Service Bulletin

S.B. No: 162

INSPECTION OF PITOT TUBE INLET PIPE AND LIGHTNING CONDUCTOR

FOR CRACKING

Figure 1 Pitot Tube Installation

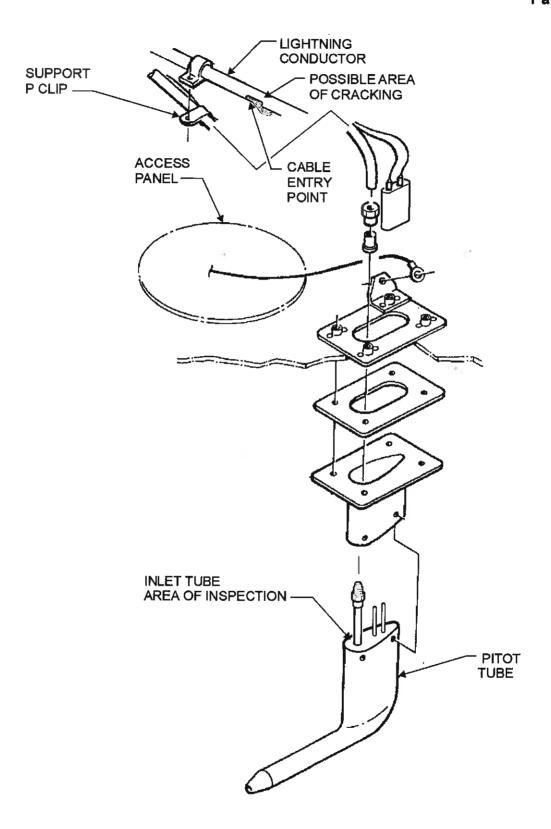
- iv. Remove the four crosshead screws holding the mounting bracket to the pitot head.
- v. Carefully ease the pitot head out of the mounting bracket.
- vi. Carefully remove the electrical connector.
- 3. Perform visual check for cracks in the inlet tube of the pitot in the area shown in Figure 1.
- 4. Perform check port and starboard on lightning conductor for cracks.
- 5. If no visual sign of cracking exists on the pitot, refit pitot tube. Re-fit in reverse order of removal, ref paragraph 2.

- 6. If signs of cracking exist in the pitot head tube, replace with a new item. Re-fit in reverse order of removal, ref paragraph 2. For purchase, please contact SAL Product Support Department.
- 7. If cracking exists in lightning conductor, repair in accordance with T67B-03-029.
- 8. Ensure pipe is properly supported (ref P-clip, Figure 1), and care is to be taken that inlet pipe is not stressed during installation and future maintenance. Note to this effect will be added to Maintenance Manual together with removal and installation procedure.
- 9. Replace access panels.
- 10. Attach placard T67B-00-305 as indicated by Figure 2. Both port and starboard access holes.
- 11. Annotate in aircraft logbook "SB 162 complied with, Mod M934A incorporated".

Figure 2 Showing Access Panels and Placard Position

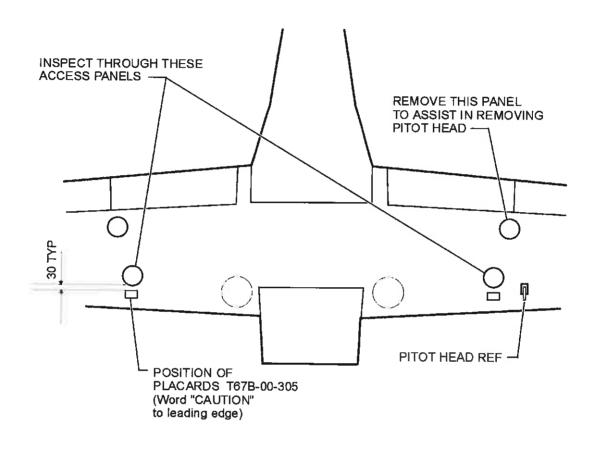
Additionally, a case has been reported of cracked lightning conductor at the access holes indicated, ref Figure 2. An inspection is also required to check for any cracking in the lightning conductor and rectification as required.

- 1. Remove access panels indicated by Figure 2.
- Carefully remove pitot tube from lower wing surface as follows:
 - i. Ensure that the master switch and heated pitot switch are both OFF.
 - ii. Remove two inspection panel covers, one next to the pitot head and one further aft near the flap centre bearing rib.
